Report to Norwich highways agency committee

Subject Transport for Norwich – Cycling improvements
St Clements Hill

To consider the responses to St Clements Hill junction improvements and 20mph area statutory consultation and approve the amended proposals for installation.

Title Transport For Norwich St Clements Hill Traffic Calming Proposed 20mph changes	Date	Scale(s)				
	22-07-2016	NTS	No.	Date	Notes	REVISIONS
	Drawn By	Designed By				
	JG	AE				
Checked By	NEG. No.					
LA						
DWG. No.						
CCAG2-36-028

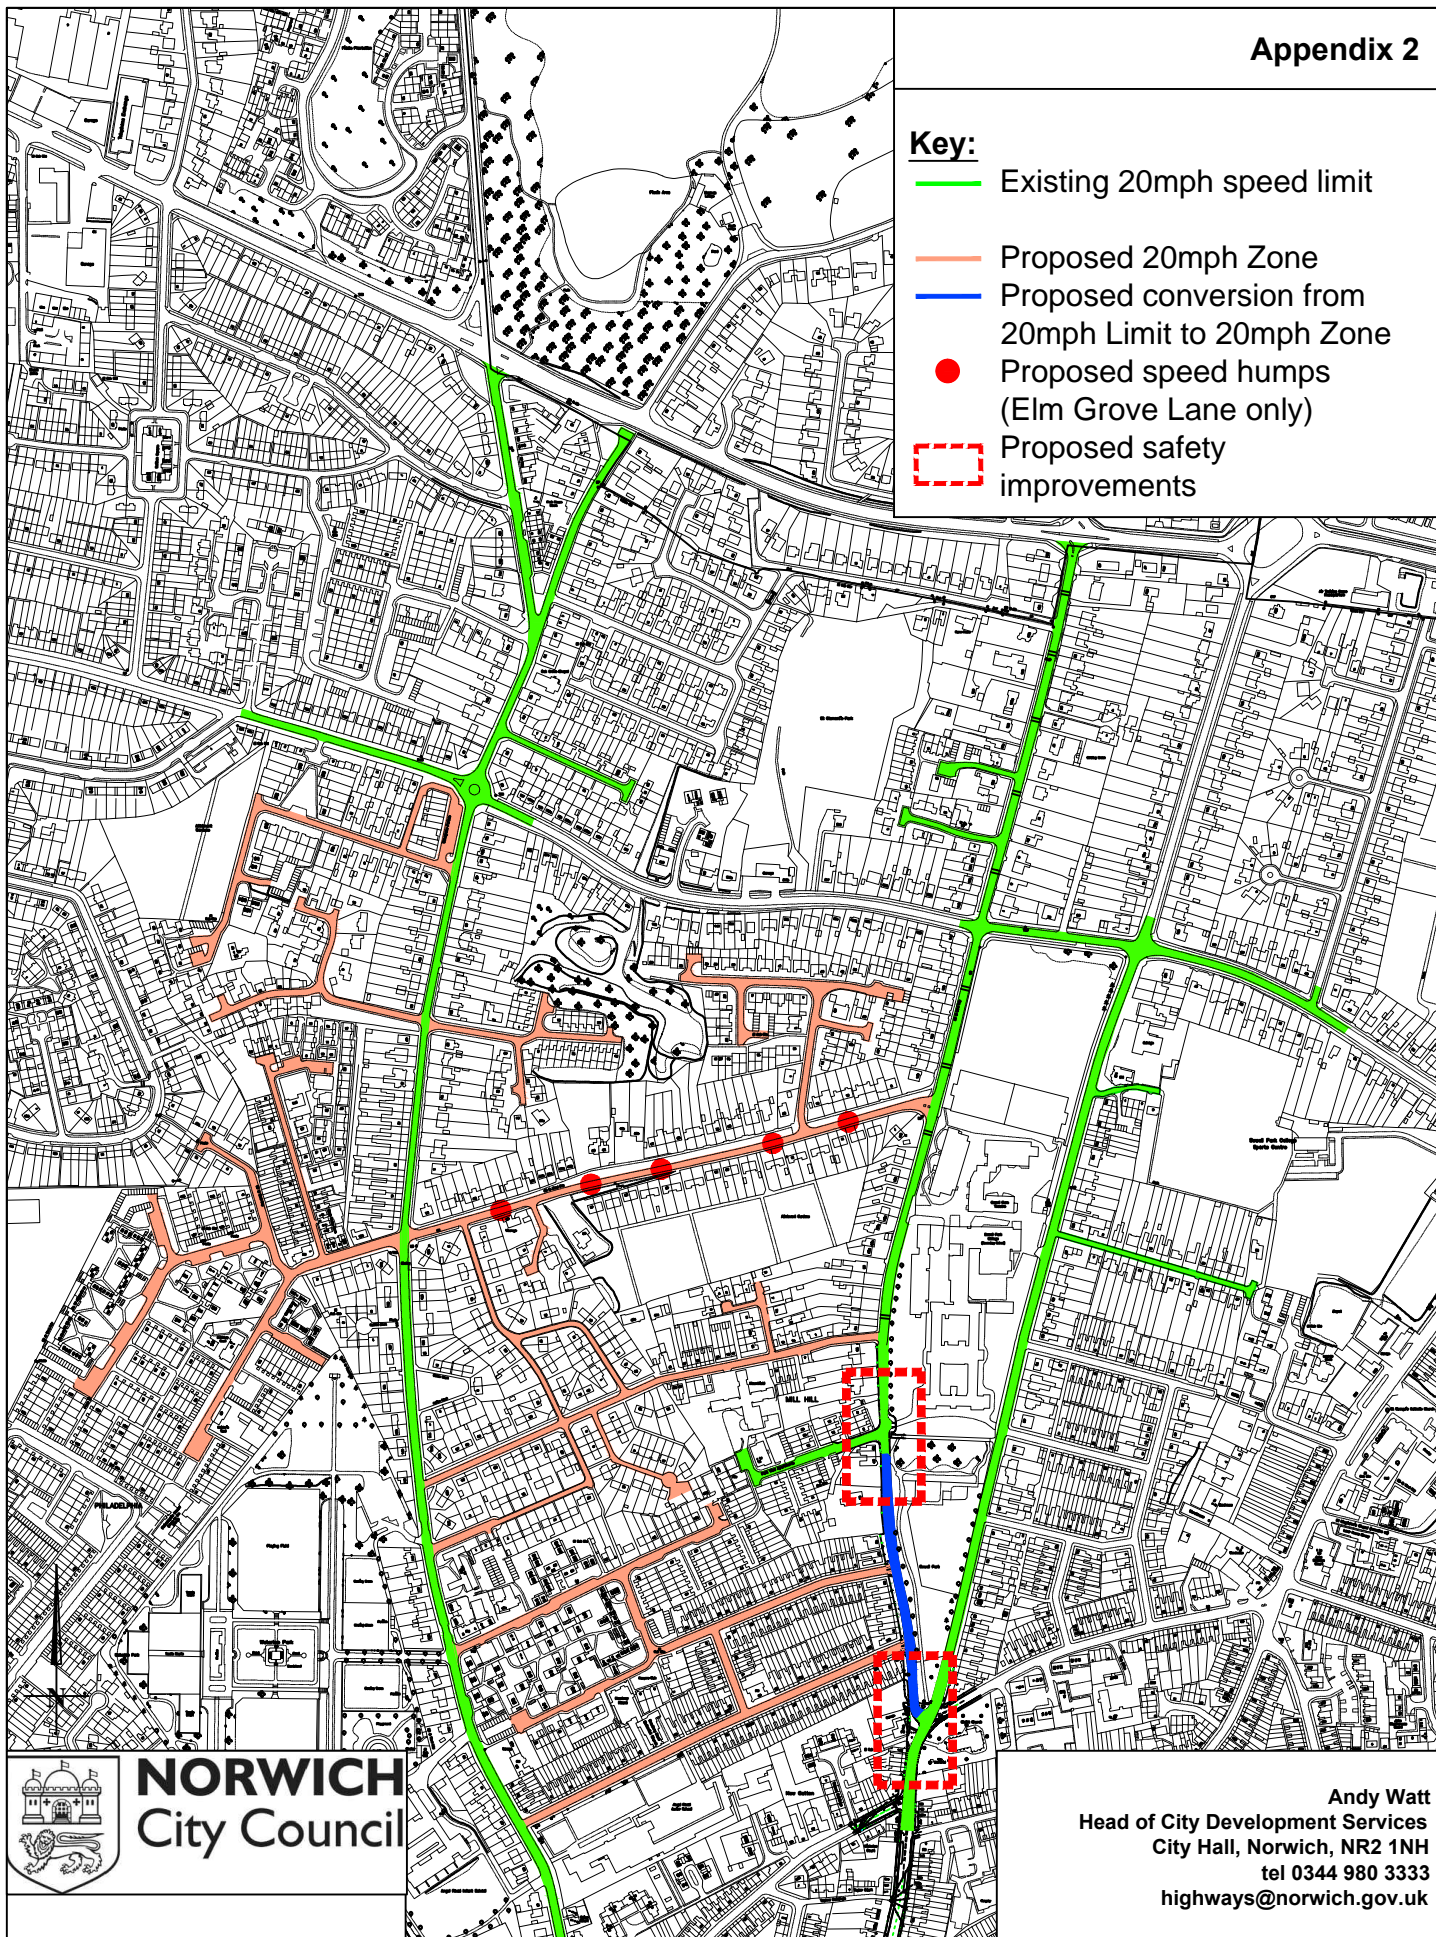
15. Most responses either agreed with the introduction of the 20mph zone extension or did not refer to it but gave concerns on the specific design at locations. For this reason it seems fair to deduce that the majority of respondents have no objection to the 20mph extension in general.

- the 20mph area as advertised with the traffic calming on Elm Grove Lane
- Millcroft junction proposals with reduced double yellow lines into Millcroft and including the removal of guard railing
- The raised table on St Clements Hill by the junction with Magdalen Road and install the existing zebra on a raised table with associated works.

No.	Date	Notes	REVISIONS	Int.	Ckd.	Date	Scale(s)
						21/07/2016	NTS
						Drawn By JG	Designed By AE
						Checked By AE	NEG. No.
						DWG. No. CCAG2-36-025

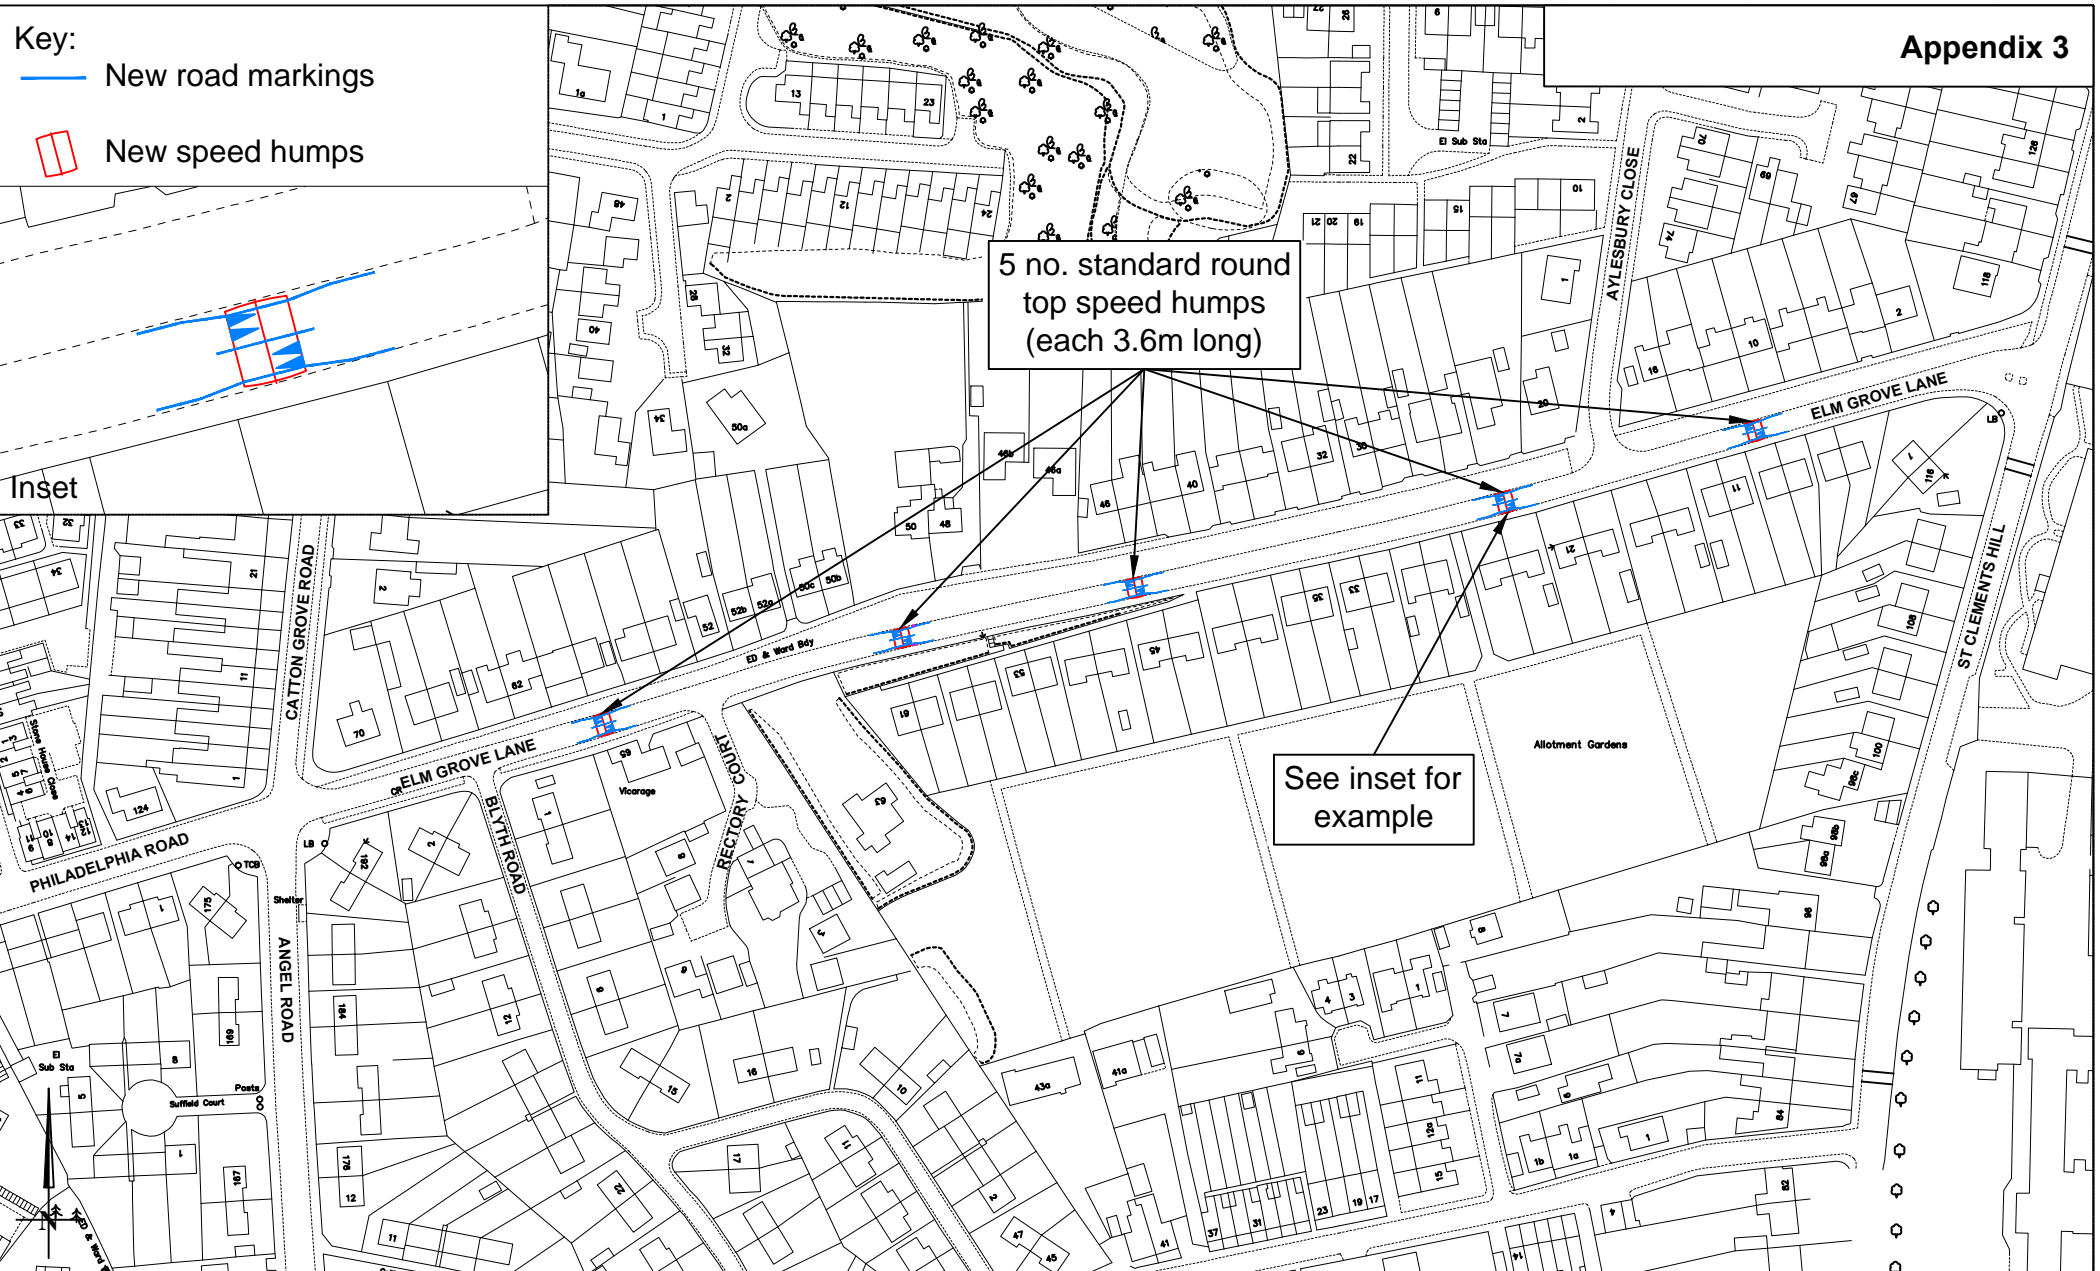
16. The number of respondents agreeing with the proposed traffic calming on Elm Grove Lane was marginally higher than the objections. Some concerns were voiced on the design of speed hump and suggesting the proposed speed humps were not cycle friendly. The main objections were that the responder believed the humps were not necessary due to the number of parked cars and existing speed of traffic.

No. of responses from residents	Comments received	Officer comments
1	As a cyclist and motorcyclist I find speed humps highly dangerous, especially at night and particularly down a steep hill such as Elm Grove Lane.	The speed humps are designed for all traffic and as such a cyclist or motorcyclist should be able to negotiate them at an appropriate speed.
2	Speed humps and cushions cause discomfort and inconvenience to cyclists.	Traffic calming is necessary on some roads to keep traffic speed down to 20mph. The benefit to cyclists of reduced traffic speeds should outweigh the inconvenience.
3	Money would be better spent on maintaining the roads.	The budget for this proposal is specifically allocated for cycling improvements and cannot be used as revenue for highways maintenance. However where we are installing items on the highway, the road will be resurfaced where necessary.
1	Concerned that the speed hump design will force cyclists into the path of vehicles.	The design is for a full width hump with a drainage channel at the kerb edge. The recommended position for cyclists to take on the highway is around 1m from the kerb edge. In this position there will be no need for the cyclist to move into the road.

25. There is some resistance to the installation of speed humps to act as traffic calming on some roads. However, if the public wants 20mph areas, it is necessary for those areas to be self-enforcing. Guidance from the Department for Transport (DfT) advises that in areas where existing traffic speeds are 24mph or over, then it is recommended to provide traffic calming if a 20mph speed limit is introduced. The existing average traffic speeds on Elm Grove Lane in an easterly direction were recorded as 26mph. The traffic calming has been designed to work in an environment with parked vehicles and cyclists. The inconvenience to drivers of the speed humps is outweighed by the benefit to cyclists and pedestrians in a 20mph environment.

No. of responses from residents	Comments received	Officer comments
Sewell ward councillors	<p>At the Magdalen Road junction, do not agree with the cycle track, tree or cycle racks.</p> <p>At the St Clements Hill / Millcroft junction, the railings should remain and the double yellow lines on Millcroft are not needed.</p>	<p>Support welcome for the 20mph and traffic calming. Agree there is a potential for conflict between cyclists and pedestrians at the Magdalen Road junction. The yellow lines on Millcroft could be shortened, but the junction must be protected from parked vehicles for drivers and pedestrians visibility. Recent guidance from the DfT advises to remove pedestrian guardrails to reduce street clutter, make the environment more “open” and encourage awareness of other road users. In this 20mph area guardrails are not necessary.</p>
Sewell residents meeting	<p>Magdalen Road junction, do not agree with the cycle track, tree or cycle racks. Concerns with cycle speeds, collisions with pedestrians, nearby vehicle accesses, visibility at the junction and car club space position. Also concerns for the Whalebone deliveries.</p> <p>Would prefer a traffic signal crossing instead of the existing zebra at the Magdalen Road junction.</p> <p>Millcroft junction, the yellow lines on St Clements Hill and Millcroft should be reduced as parking is limited. The footpath buildouts and pedestrian guardrails should remain. Drivers visibility needs improving when emerging from Millcroft.</p> <p>Consider a mini roundabout at the Magdalen Road junction.</p> <p>Elm Grove Lane speed humps should be the full width of the road.</p>	<p>Agree there is a potential for conflict between cyclists and pedestrians at the Magdalen Road junction. A traffic signal pedestrian crossing is not considered necessary in a 20mph zone. The proposed raised table will slow traffic down and help pedestrians feel more confident on the zebra crossing.</p> <p>The proposed yellow lines on St Clements Hill are necessary to allow free passage of vehicles. However, the ones advertised for Millcroft could be shortened, but the junction must be protected from parked vehicles for drivers and pedestrians visibility. Recent guidance from the DfT advises to remove pedestrian guardrails to reduce street clutter, make the environment more “open” and encourage awareness of other road users. In this 20mph area guardrails are not necessary. A mini roundabout at the Magdalen Road junction is not possible due to the alignment of the joining roads. The proposed speed humps on Elm Grove Lane are full road width except for a drainage gully on each kerb line.</p>

Title Transport For Norwich St Clements Hill Traffic Calming Proposed St Clements Hill / Millcroft junction layout	Date	22-07-2016	Scale(s)	NTS	No.	Date	Notes	REVISIONS	Int.	Ckd.
	Drawn By	JG/AE	Designed By	AE						
	Checked By	LA	NEG. No.							
	DWG. No.	CCAG2-36-027

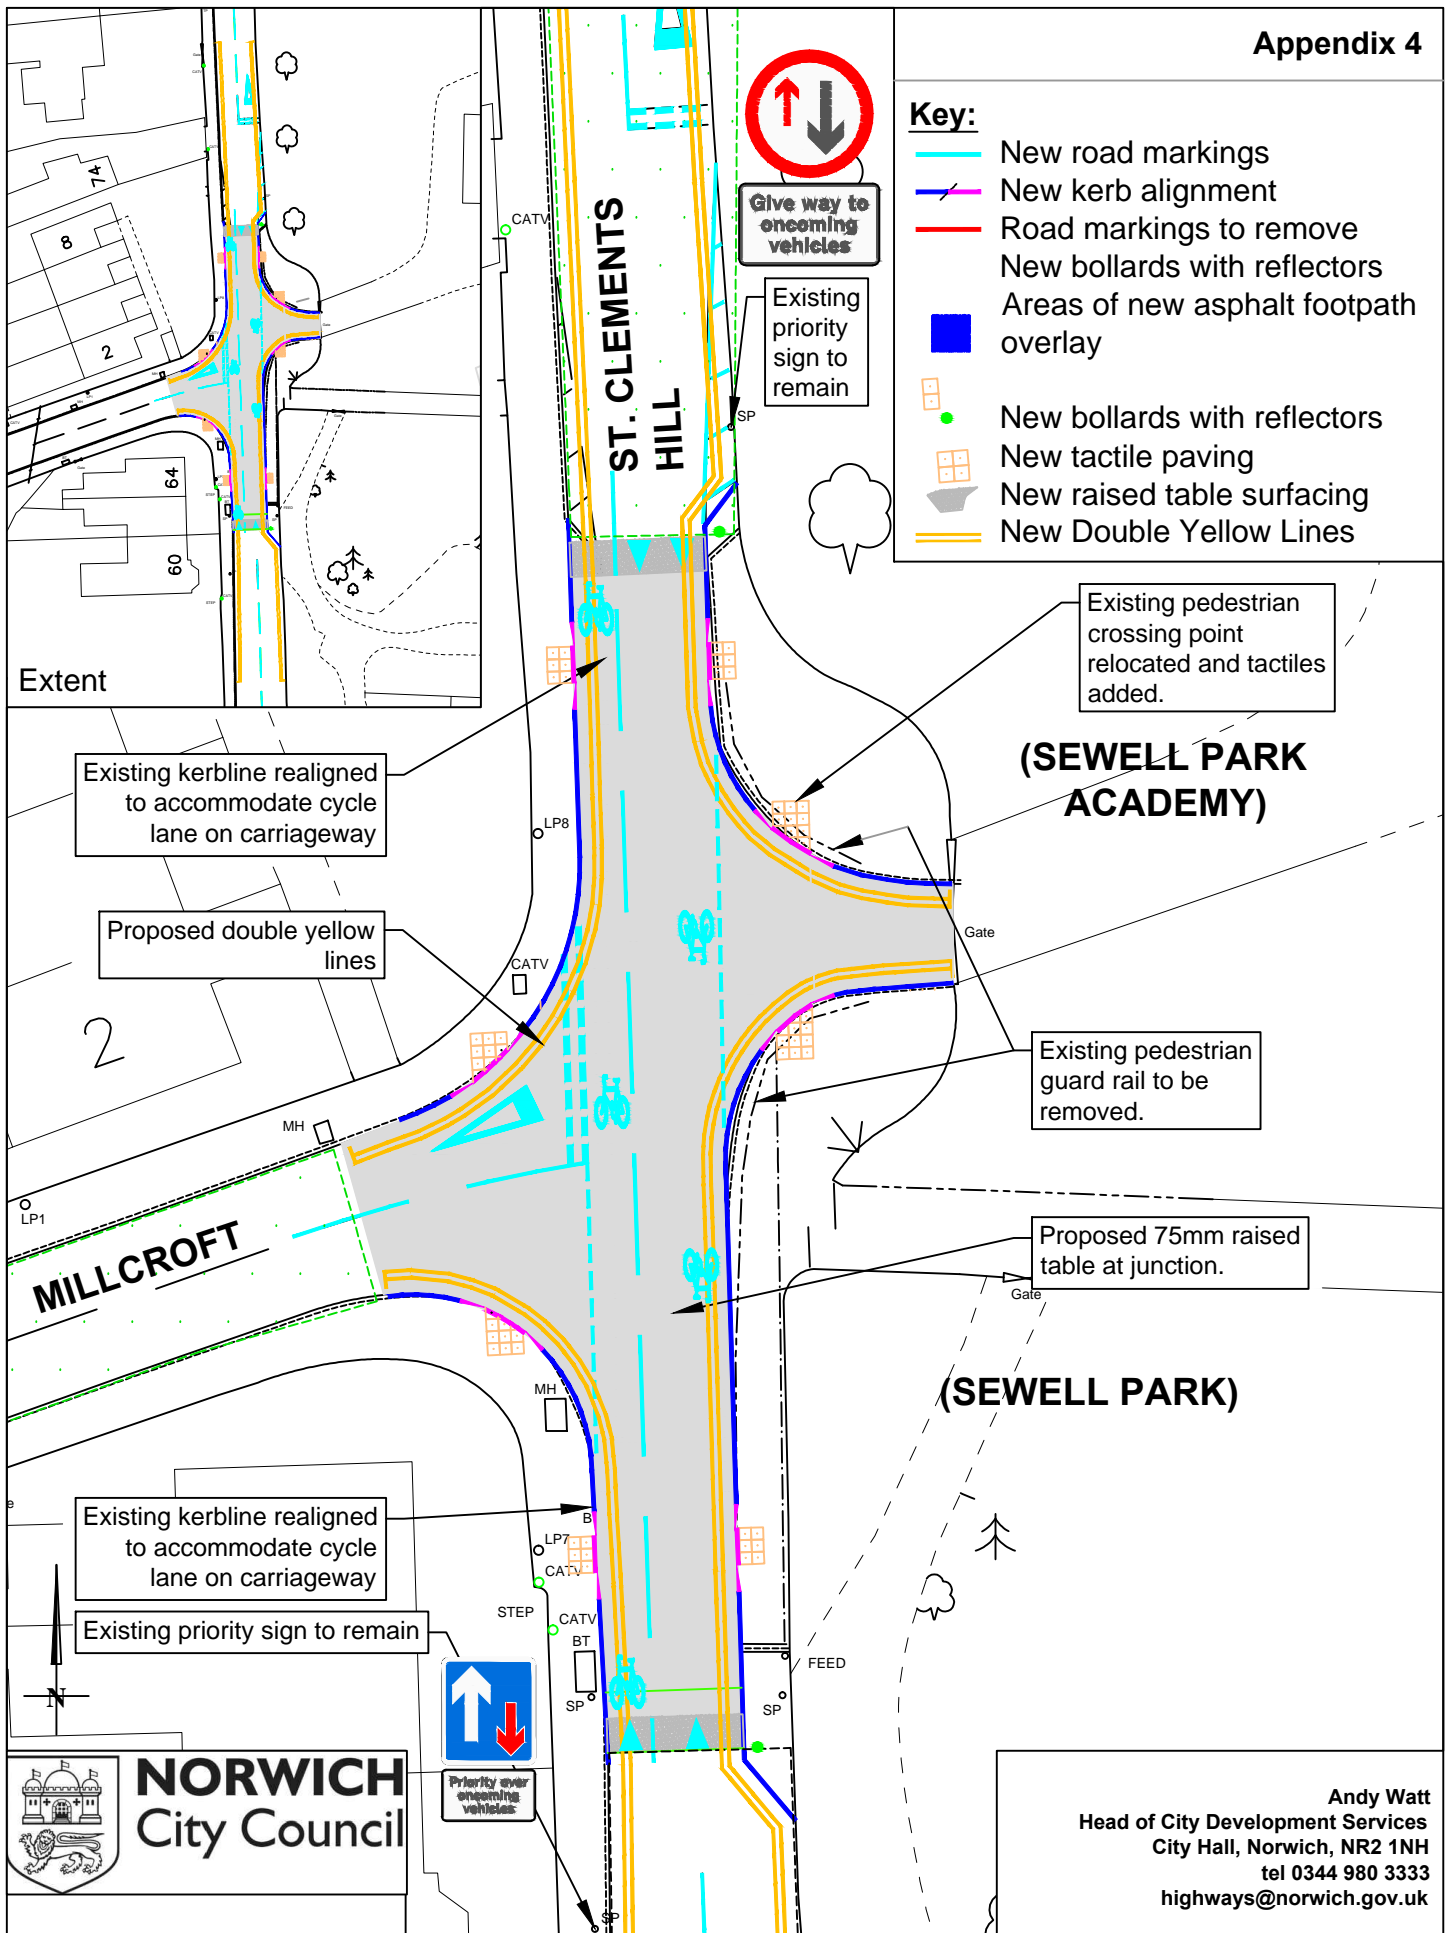
17. Most respondents did not voice an opinion on the overall design of the junction improvement, but did express concern at either the removal of pedestrian guardrails or the length of proposed double yellow lines due to limited space for residents parking. Many were concerned with the safety of children at this junction due to the entrance to Sewell Park Academy and Sewell Park.

No. of responses from residents	Comments received	Officer comments
4	Concerned with less residents parking with the proposed double yellow lines at the Millcroft / St Clements Hill junction.	Residents parking is important, however for road safety reasons it is necessary not to park near junctions and where the road is too narrow.
1	Has witnessed no accidents at this junction in 14 years, the junction does not need “fixing”.	Traffic accident records do not give the full picture of an area. These proposals are to make cycling more enjoyable and to enhance the area by removing street clutter.
1	The raised table at the junction is too long and will not slow traffic.	It is important for the raised table to cover the complete junction and road narrowing to aid pedestrians crossing the road and to slow traffic.
2	Would like to see proposed double yellow lines on St Clements Hill extended further north. Traffic is frequently blocked as cars need to wait by parked cars for the giveway system. The road is not wide enough for parking and two way traffic.	The length of the double yellow lines on St Clements Hill have been designed to allow a medium sized lorry to comfortably wait in an area where they can be passed by oncoming vehicles. It is necessary to leave room for residents parking and parked cars do have the added benefit of slowing traffic down.

2	The proposed small section of cycle lane is not needed; resources should concentrate on more substantial provisions on main routes.	The proposed section of cycle lane at the Millcroft junction is designed to make drivers more aware of cyclists and give a priority to cyclists travelling up hill on this narrow section of road. As stated in the report, this scheme forms part of a larger scheme to enhance the complete blue pedalway.
2	Displaced cars from the proposed double yellow lines will just move further up the hill and into side roads.	It is recognised that waiting restrictions push parking further along the road, for this reason the proposal covers the area essential for road safety or traffic flow.
1	Suggests provision of parking lay-bys on St Clements Hill.	As previously stated, the budget for this proposal is specifically allocated for cycling improvements and cannot be used for other highway improvements. A lay-by for cars would not provide a benefit to cyclists.

26. At the Millcroft / St Clements Hill junction, the proposed speed table and kerb realignment, with advisory cycle lane are considered appropriate for a 20mph area. Recent guidance from the DfT advises to remove pedestrian guardrails where they are not considered essential for road safety to reduce street clutter, make the environment more "open" and encourage awareness of other road users. A number of objections to the removal of these railings were stated as there is an entrance to Sewell Park Academy and Sewell Park at this junction. However, this is the vehicle access to the main administration building of the Academy and is not used by a large number of school children. The path accessing Sewell Park has staggered barriers that will stop young children running out onto the road. The proposed double yellow lines at this junction provide an area with no parked cars which allows sufficient road width for vehicles to pass at the signed giveway sections on St Clements Hill.

27. The proposed double yellow lines on Millcroft are to enable good visibility and manoeuvring at this junction. However as Millcroft is a small residential cul-de-sac with limited vehicle movements, it is considered suitable to shorten the proposed restrictions to cover just the raised table into Millcroft. This will allow enough space for an extra two vehicles to park.
